COA # 2010-COA-406 (SJ) Part B	INDIANAPOLIS HISTORIC PRESERVATION COMMISSION STAFF REPORT	Hearing Date MAR. 2, 2011
		New Case
956-962 N. PENNSYLVANIA ST ST. JOSEPH		
Applicant & mailing address:	HALSTEAD ARCHITECTS 1139 Shelby St Indianapolis, IN 46203	
Owner:	HVAF of Indiana	Center Township Council District: 9 Jackie Nytes
CASE		
IHPC COA: 2010-COA-406 (SJ)	<ul style="list-style-type: none"> • Replace vinyl windows with new vinyl windows • Remove two chimneys 	
STAFF RECOMMENDATION: Approval of a Certificate of Authorization		
STAFF COMMENTS

THE MANCHESTER APARTMENTS
RESTORATION AND RENOVATION
 956-962 N. PENNSYLVANIA STREET
 INDIANAPOLIS, INDIANA

Below: Sample Silverline Window by Anderson being proposed (no muntins)

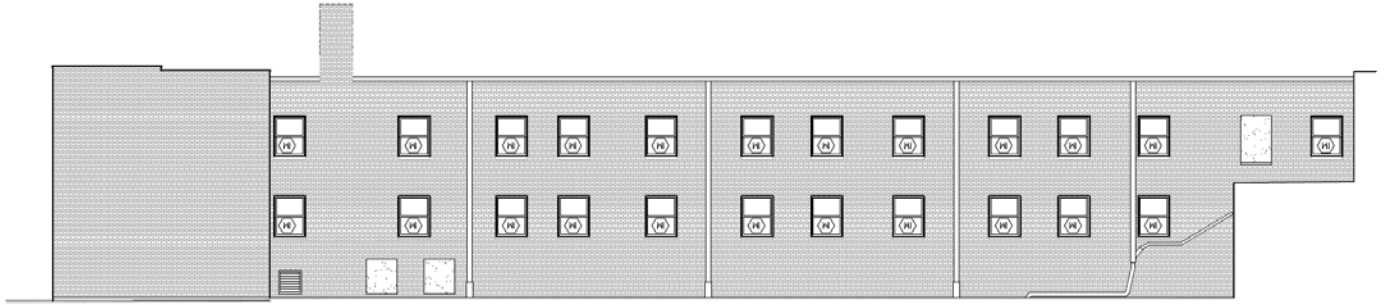
The applicant is proposing to install Anderson, buff colored vinyl single-hung windows (with no muntins.) They will only be installed in openings where there are currently vinyl windows installed. A few original steel windows are left on the west and courtyard sides of the building and will not be removed or altered. All the exterior (non-courtyard) windows will fit the openings properly, unlike the windows that were installed in 1997 and required an awkward side-lite filler panel.

1. **New windows are to be approved by IHPC staff prior to installation. Approved _____ Date _____**
2. **New windows must be configured per the submitted elevation drawings provided in this report.**
3. **Color of new windows shall not be white. Final color selection is to be approved by IHPC staff prior to installation. Approved _____ Date _____**
4. **Chimneys are to be removed to roofline and capped off. Capping of chimney stacks shall be approved by IHPC staff prior to commencement of work. Approved _____ Date _____**
